TransGrid Revenue Proposal 2023-28

# **REVIEW OF RIT-T PROJECT: IMPROVING STABILITY IN SOUTH- WESTERN NSW - PUBLIC VERSION**

Report prepared for:  
**AUSTRALIAN ENERGY  
REGULATOR**  
August 2022

Figure 3.2: Cumulative benefits and NPV for Option 4, weighted average scenario, as presented by Transgrid

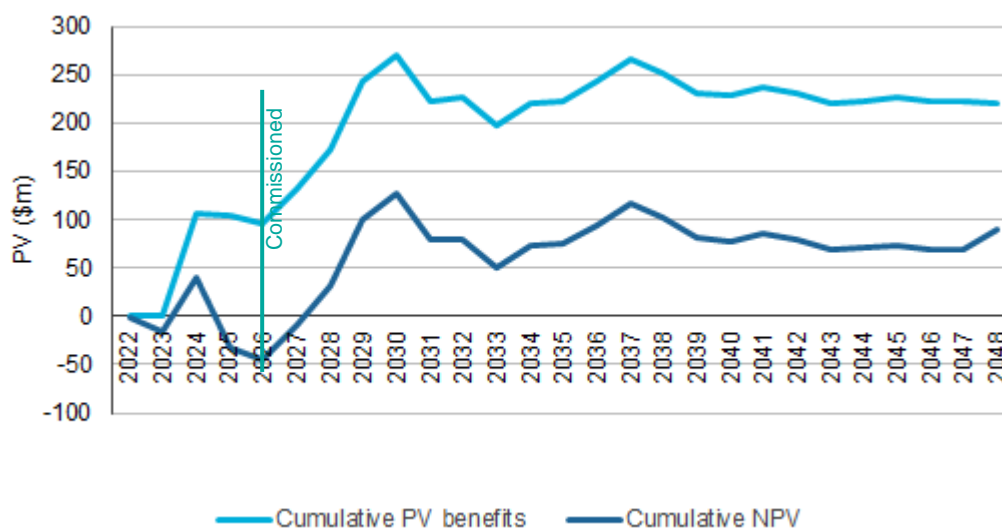
- 130. Of significant concern in seeking to interpret the modelling of benefits is that, as can be seen in Figure 3.2, around \$100m of the benefits (in PV terms) is accrued before the project is commissioned. We infer that this could reflect the benefits resulting from the BESS, which is to be commissioned in 2024. All of the Transgrid costs of the project, however, are network costs (i.e. for the new 330kV line and substation costs) in which case the

148. As we showed in Figure 3.2, the main sources of benefit for this project are realised in the first few years of the assessment period, primarily as a result of deferred generation. This places a higher value on delivering potential solutions as early as possible, noting that any investment needs to be considered over its full economic life.

Figure 3.3: Transgrid's assessed net present value for each scenario

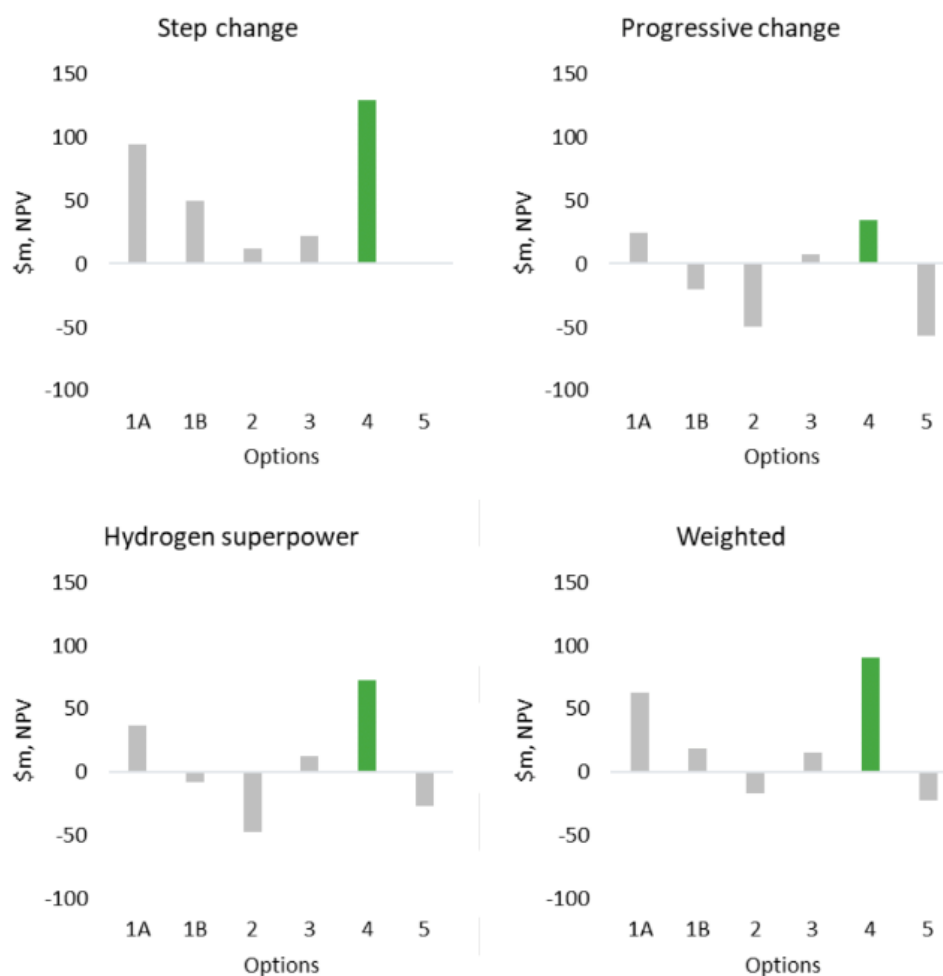
138. Transgrid has updated its CBA and provided an updated NPV model for our review.<sup>41</sup> In this model, the commissioning timing is pushed out to 2025/26 for all options except option 5 (network battery only).
139. A summary of Transgrid's NPV analysis for each of the 6 options assessed, for the 3 ISP scenarios and the weighted scenario is provided in Figure 3.3.

- 142. From Transgrid's PACR modelling, Option 4 is assessed as delivering an estimated net present value of \$91m (on a scenario-weighted basis). Option 4 involves utilising a BESS development that is currently going ahead independent of this RIT-T (i.e., it is considered 'committed' under the RIT-T) to provide interim network support from 2023-24 and the establishment of a new greenfield transmission line between Darlington Point and the new Dinawan substation (that will be developed as part of EnergyConnect), with an estimated capital cost of \$166.9m.

Figure 3.4: Cumulative PV of benefits and of NPV, with benefits commencing only after commissioning of the network project

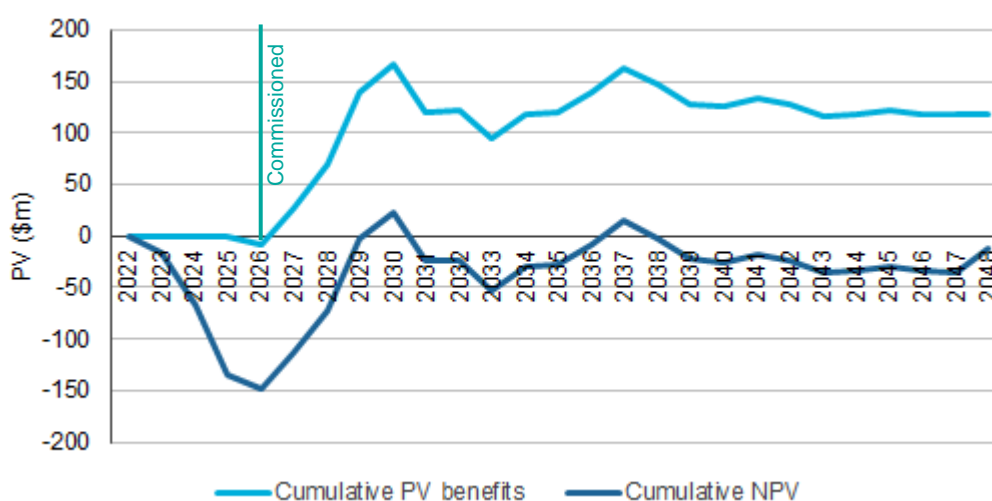
- 167. In Figure 3.4, we show the cumulative PV of benefits and of the project NPV, if we attribute benefits to the project only after it is commissioned. With this assumption, there is essentially no payback and the overall NPV is negative.<sup>44</sup>
